Proposed Revision of the Transmission Expansion and Interconnection (TEI) Manual

Business Issues Committee

October 14, 2015

Proposed Change to the Criteria for Requiring an SIS: Example of Application

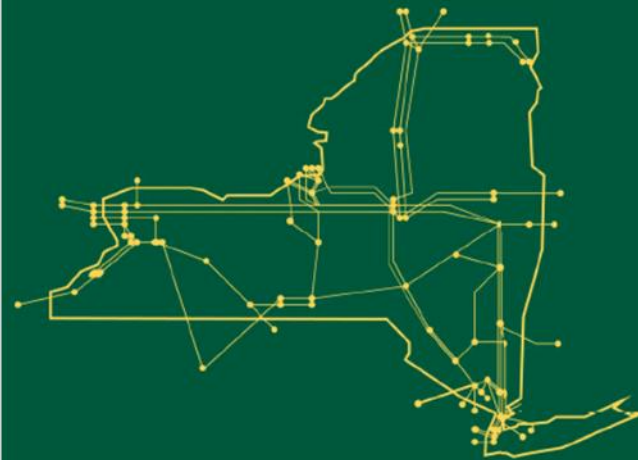
- ◆ Queue# 505A – Central Hudson’s proposed Hurley Avenue & Saugerties upgrades.
 - *SIS Scope approved by the Operating Committee on 8/13/2015*
 - *Project - Rebuild of Central Hudson Gas & Electric Corporation’s (“CHG&E”) 69 kV SB line (Hurley Avenue – Saugerties) and 69 kV H line (Saugerties – Cement – North Catskill) (reference SIS Scope for details)*
 - *Central Hudson provided analysis to NYISO showing the project results in a “small” increase in UPNY-SENY thermal transfer limits in the range of 2 to 21 MW, and petitioned NYISO to “waive” the requirement for a NYISO SIS.*
 - *NYISO proposed rule change would eliminate the requirement for a proposed transmission upgrade such as this to undergo a NYISO SIS.*
